QUALITY ASSURANCE -- NON-CONFORMANCE REPORT

Location: Changxing Island, Shanghai, P.R. China**Report No:** NCR-000284**Prime Contractor:** American Bridge/Fluor Enterprises, a JV**Date:** 19-May-2009**Submitting Contractor:** Zhenhua Port Machinery Company, Ltd (ZPMC), Changxing Island**NCR #:** ZPMC-0258**Type of problem:**

Reference Description: Missed MT/VT by QC, Segment 1AAE**Description of Non-Conformance:**

Job Name: SAS Superstructure

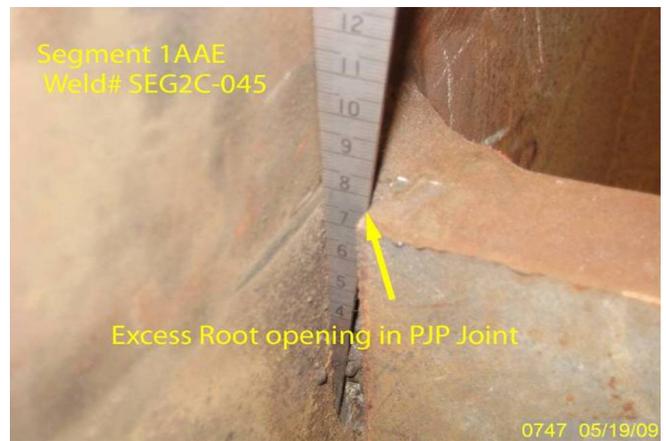
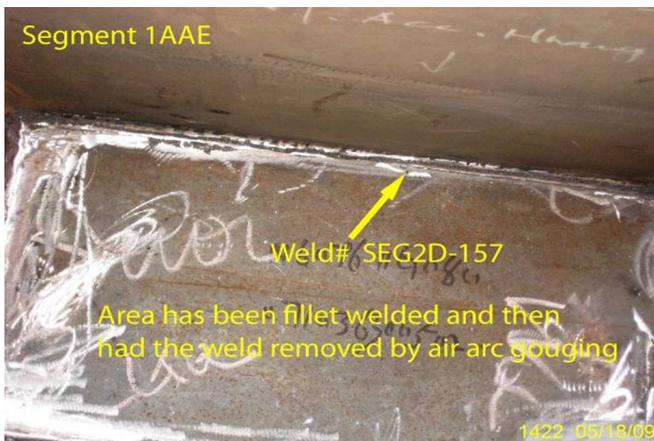
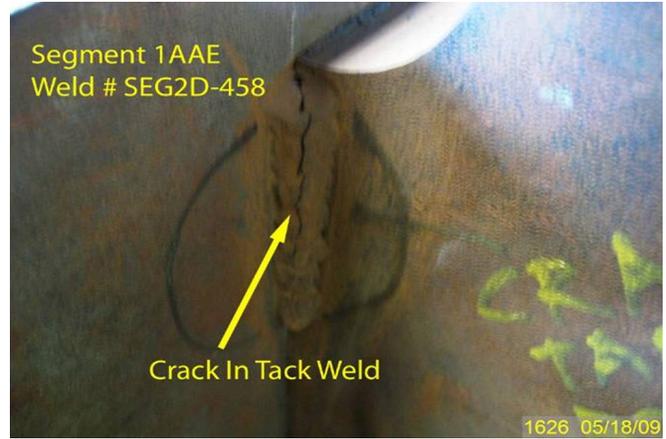
Caltrans Quality Assurance (QA) Inspector found the following indications and discontinuities by Visual Testing (VT) and Magnetic Particle Testing (MT) on welds previously inspected and accepted by ZPMC Quality Control (QC) Inspectors.

- Four linear indications (transverse) were discovered by MT on weld joint# Seg2-036 (corner assembly joint). After removing the indications by grinding, the resulting weld was accepted by ZPMC-QC and Caltrans-QA.

- Joint offset (misalignment) was found in weld #Seg2-021 and Seg2-019. The measured offset is approximately 5mm.
- SEG2C-045 - PJP weld root opening is approximately 8 mm. SEG2E-137 - PJP weld root opening exceeds allowable tolerances of WPS-B-T-2333-Tc-U4b-F.

- SEG2E-458- Crack in tack weld
- SEG2D-157- Drawings require tight fit. The joint has been fillet welded. The weld has been removed by arc gouging resulting in base metal damage. This area cannot be measured for compliance with the tolerances for tight fit due to melted weld metal and base metal at the joint.

- SEG2D- The fit-up at the end plate and deck plate exceeds the allowable 2mm tolerance. The measured gap is approximately 8mm.

Reference Description: Missed MT/VT by QC, Segment IAAE

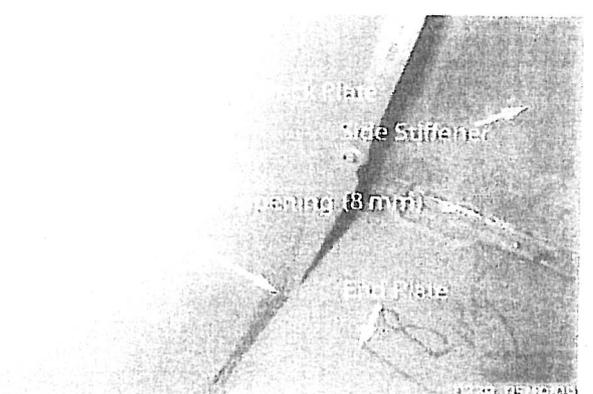
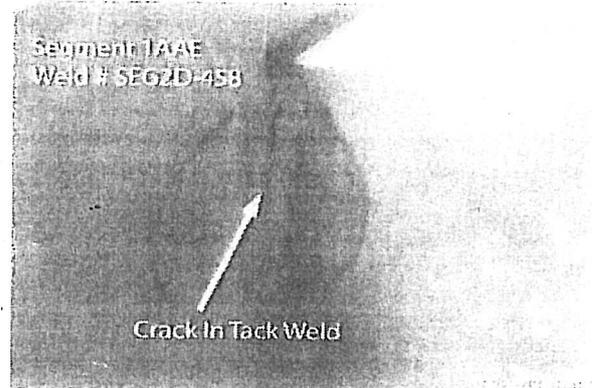
Caltrans Quality Assurance (QA) Inspector found the following indications and discontinuities by Visual Testing (VT) and Magnetic Particle Testing (MT) on welds previously inspected and accepted by ZPMC Quality Control (QC) Inspectors.

- Four linear indications (transverse) were discovered by MT on weld joint# Seg2-036 (corner assembly joint). After removing the indications by grinding, the resulting weld was accepted by ZPMC-QC and Caltrans-QA.

- Joint offset (misalignment) was found in weld #Seg2-021 and Seg2-019. The measured offset is approximately 5mm.
- SEG2C-045 - PJP weld root opening is approximately 8 mm. SEG2E-137 - PJP weld root opening exceeds allowable tolerances of WPS-B-T-2333-Tc-U4b-F.

- SEG2E-458- Crack in tack weld
- SEG2D-157- Drawings require tight fit. The joint has been fillet welded. The weld has been removed by arc gouging resulting in base metal damage. This area cannot be measured for compliance with the tolerances for tight fit due to melted weld metal and base metal at the joint.

- SEG2D- The fit-up at the end plate and deck plate exceeds the allowable 2mm tolerance. The measured gap is approximately 8mm.

项目名称 Project Name:	美国海湾大桥 SFOBB	部件图号 Drawing No.:	SEG2	报告编号 Report No.:	B-WR5828
合同号 Contract No.:	04-0120F4	部件名称 Item Name:	1AAE	NDT 报告编号 NDT Report No.:	NA
项目编号 Project No.:	ZP06-787

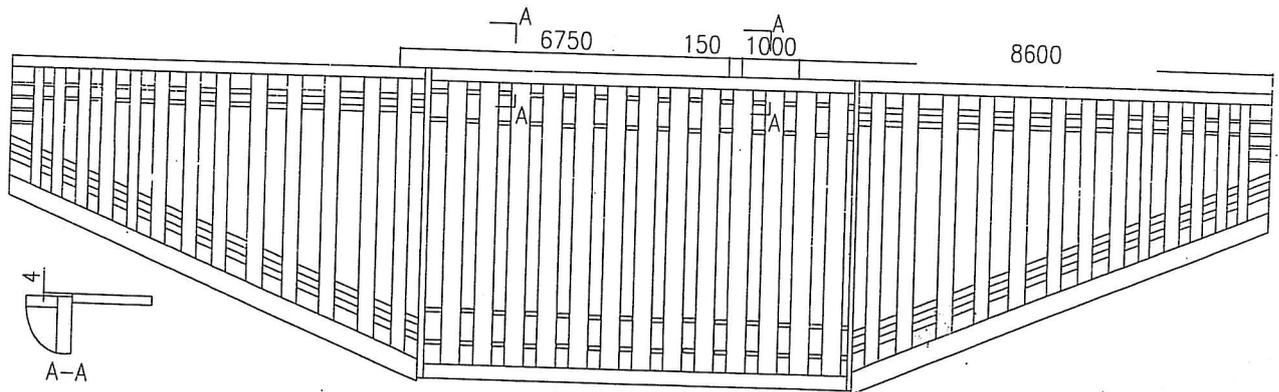
胡国兴队制作1AAE整体焊后，顶板与顶板筋板在图示位置存在错位。

After welding 1AAE fabricated by work team: Hu Guoxing, the misalignment existed on deck plate and stiffener.

焊工操作失误, 导致焊接变形。

The welder operated error caused welding distortion.

1. 将错边超差区域端封板与顶板筋板之间的焊缝碳刨到约20mm(不得刨穿)深度后, 采用热切割(割缝间隙尽可能小)将焊缝分开。碳刨前根据相应的WPS进行预热。碳刨时不得伤及母材;
 2. 采用打磨或碳刨的方法去除返修区域筋板与顶板筋板之间的角焊缝。碳刨前根据相应的WPS进行预热;
 3. 打磨去除缺陷, 并进行MT检测;

4. 采用外力调整错边量及平整度到公差要求的范围内;
 5. 根据相应的返修WPS准备焊接接头;
 6. 根据相应的WPS预热及焊接;(先焊接端封板及顶板筋板之间焊缝)
 7. 打磨返修区域使与周边母材平滑过渡;
 8. 根据图纸要求对返修区域进行VT及NDT检测。
1. Gouge the misaligned weld between end bulkhead and deck stiffener to the depth of about 20mm(No gouging through), and then divide the weld by heat cutting. (The cutting gap shall be as soon as narrow.) Preheat prior to gouging according to the WPS and note not to damage base metal.

2. Remove the fillet weld between deck stiffener and stiffeners in the repaired area by grinding and gouging. Preheat prior to gouging according to the WPS.

3. Remove the defects by grinding and perform MT.
 4. Adjust the misalignment and flatness to meet the requirement of shop drawing by outer force.
 5. Prepare the excavation according to the WPS.

6. Preheat and weld according to the WPS.(Perform welding between end bulkhead and deck stiffener first.)
 7. Grind the repaired area flush to base metal.

8. Perform VT and NDT according to shop drawings.

RFI No.: RFI-ZPM-000702R00 Submitted by: Ling Shihua Page(s): 1
 RFI Date: 2009-6-16 Contact Name: Lu Shihua Phone No. 021-27414950

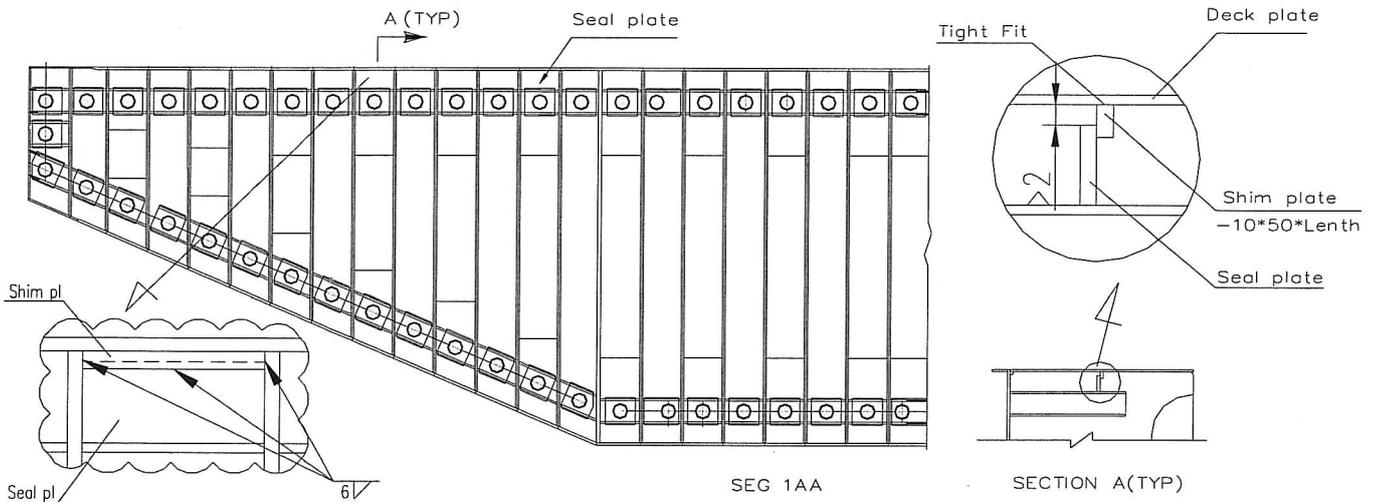
Subject: Fabrication Issue: Root Gap of PJP between End Stiffener and Strand Stiffener
References:
Response required by: <u>2009-6-17(date)</u> Response affects critical path activity? <input checked="" type="checkbox"/> YES <input type="checkbox"/> NO

During fabrication of 1AA, in the drawings of SEG1C, SEG1D, SEG2C, SEG2D, it should be tight fit between seal plates and deck plate, but shop workers missed the requirements when fitting. That led to excessive fit-up gap. For the fit-up gap >2mm, we propose to add a shim plate (A709M-345T2) tight fit to deck plates (no weld, sealed with silicone). The shim plates will be 6mm fillet welded with the seal plates and end stiffeners. For details, see the following fig.

项目名称 Project Name	美国海湾大桥 SFOBB	部件图号 Drawing No	SEG1/2	报告编号 Report No.	B-WR5642
合同号 Contract No.:	04-0120F4	部件名称 Items Name	OBG FLOOR BEAM	NDT报告编号 Report No.of NDT	NA
项目编号 Project No.:	ZP06-787

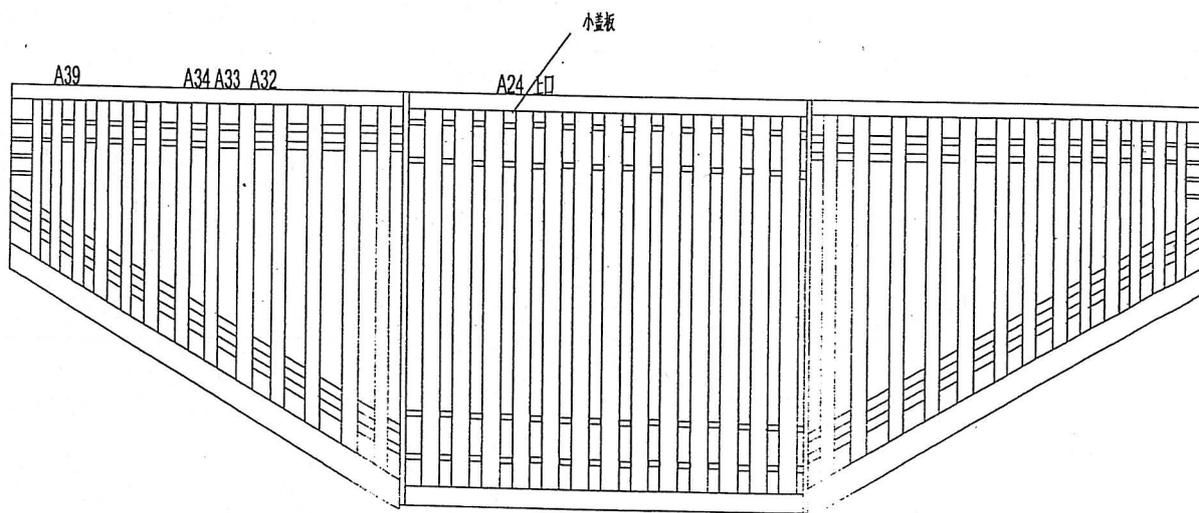
1AAW, 1AAE两个箱体顶板位置图纸上(小盖板)不允许烧焊, 现场原烧焊又割掉, 现去除小盖板。
1AAW, 1AAE box deck plate, the small cover plate didn't allow to weld, however, it has finished welding and cut it.

工人在制作时, 没有将图纸看清楚图纸要求。

Worker didn't review drawing requirement during fabrication.

1. Remove the seal plates by heat cutting or gouging, note not to gouge base metal.
2. Remove all defects and grind the area flush to base metal.
3. Perform MT of this area.
4. Re-assemble seal plates tight fit to deck plates..
